Project name WHITE TAIL RIDGE  
Civic Address 134 FRANK FISHER CR.  
House model: OAKSIDE C

LOT 127 SITE/GRADING PLAN  
WHITE TAIL RIDGE PH.IV

**Re: Proposed Single Family Dwelling, 132 Frank Fisher Crescent, Lot # 127 White Tail Ridge, Almonte, Kollaard Associates File # 230020**

With regard to structural issues only, Kollaard Associates has reviewed the following drawings:

FOUNDATION PLAN  
ELEVATION C

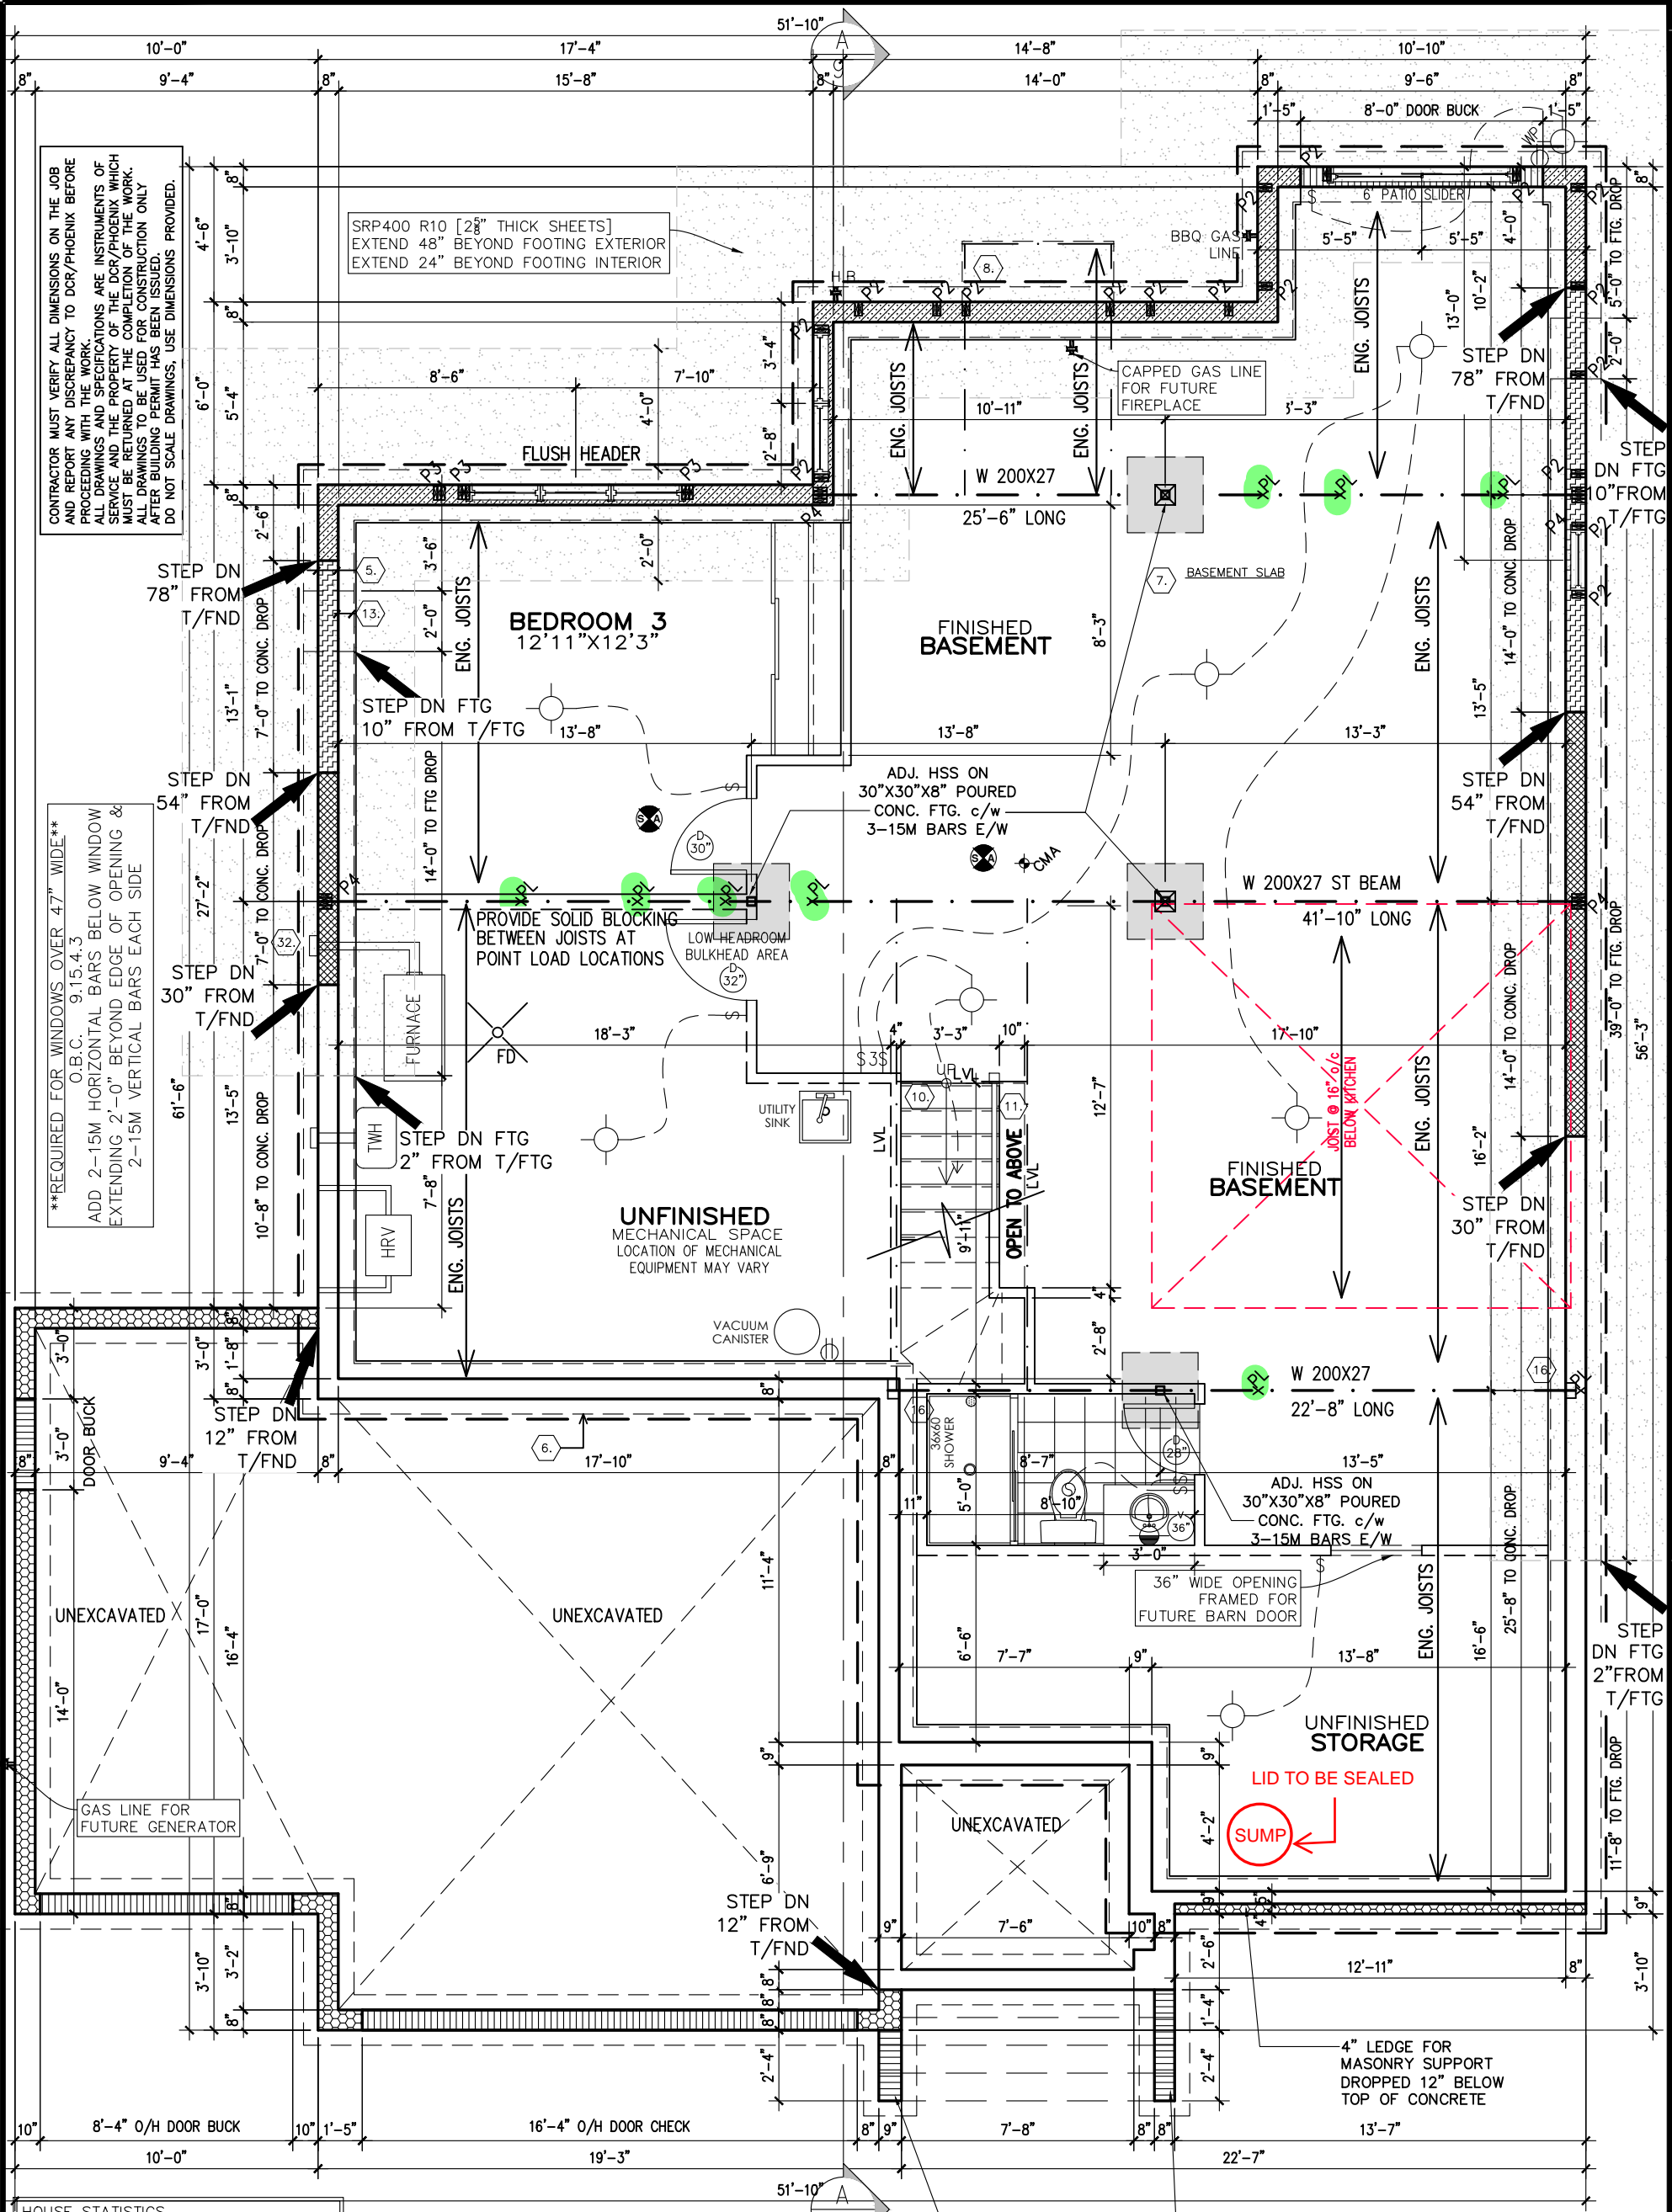
Basement Plan – Pages # 2:

4. It is the opinion of Kollaard Associates that the proposed steel beams, steel posts and built-up wood posts shown on Phoenix Homes Pages # 2 are adequate.
5. The front porch slab reinforcement described on Phoenix Homes Pages # 1 is adequate.

6. The proposed 7'-10" high foundation walls conform to 2012 OBC Table 9.15.4.2.A. ensuring the grade difference between the basement slab and the exterior finished grade (including the garage slab) does not exceed 7'-6½".
7. The proposed stepped down foundation walls with framed knee walls above conform to 2012 OBC Table 9.15.4.2.A. ensuring the grade difference between the basement slab and the exterior finished grade does **not exceed 3'-11"**.
8. The strip footings and proposed interior pad footings shown on Phoenix Homes Page # 2 and noted on Phoenix Homes Page # 1 are adequate.
9. Floor joist design, flush LVL beams/lintels within the floor structure and LVL lintels are by the manufacturer. The posts supporting the flush LVL beams/lintels shown on Phoenix Homes Pages # 2 are adequate.

# GROUND FLOOR ELEVATION C

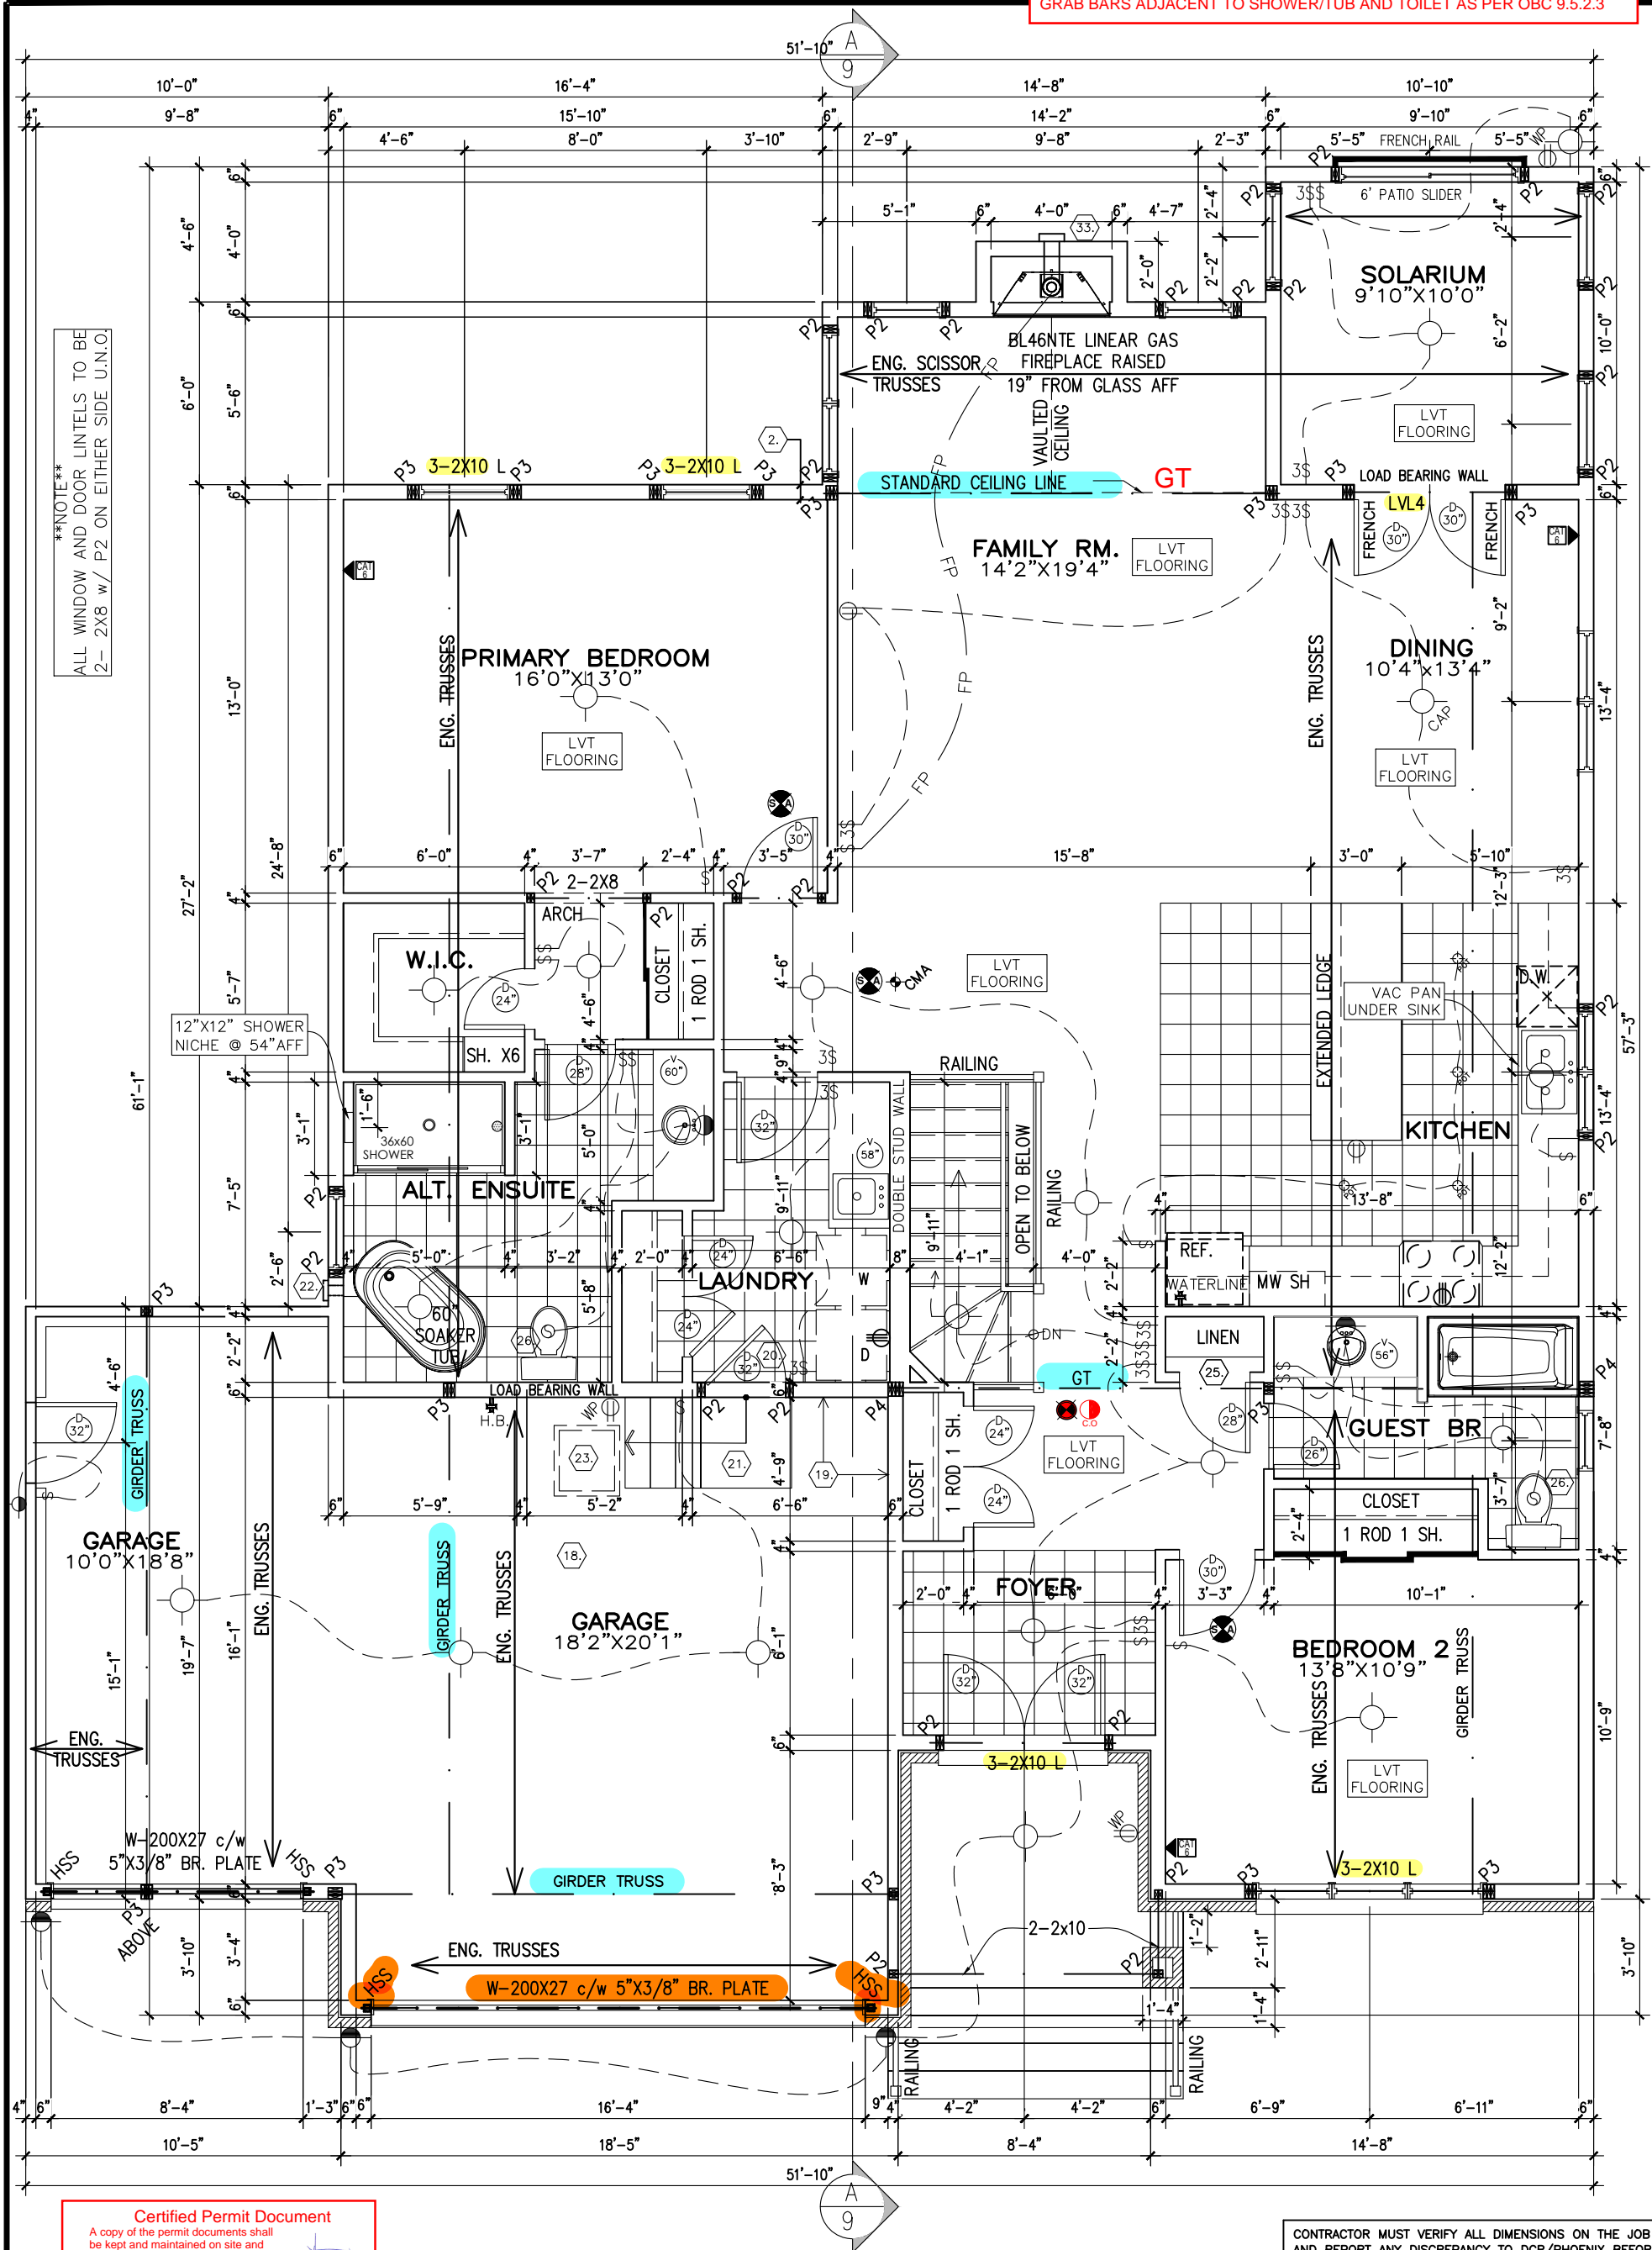
Ground Floor Plan – Pages # 3:

1. It is the opinion of Kollaard Associates that the proposed beams, lintels and supporting posts shown on Phoenix Homes Pages # 3 are adequate.
2. Posts supporting girders may consist of built up 2x6 posts as indicated on Phoenix Homes Pages # 3 and are laterally supported by plywood or OSB sheathing (i.e. posts form part of sheathed exterior walls unless noted).
3. Truss design is by others.
